TECHNICAL SERVICE BULLETIN

21-2106

Slow Fill And/Or Illuminated MIL With DTCs P0171, P0174, P0451, P0455, P0456, P0496 And/Or P1450 - Built On Or Before 30-Nov-2020

2017-2021 Transit

Figure 1

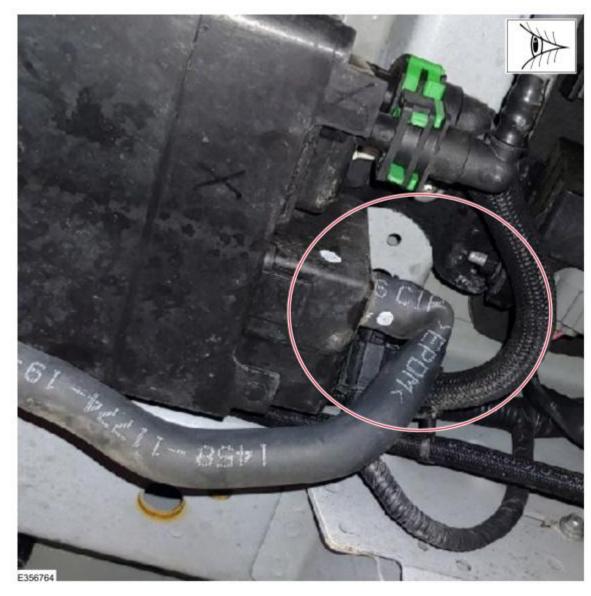
- 1. Inspect the evaporative emissions fresh air vent line near the carbon canister. Is the line kinked? (Figure 1)
 - (1). Yes proceed to Step 2.
 - (2). No this article does not apply. Refer to the Workshop Manual (WSM), Section 303-13 for normal diagnostics.

- 2. Return the fresh air vent line to its original position.
- 3. Attach a zip tie next to the C-clamp on the shepherds hook side. Make sure to align the zip tie knuckle on the opposite side of the C-clamp opening. (Figure 2)
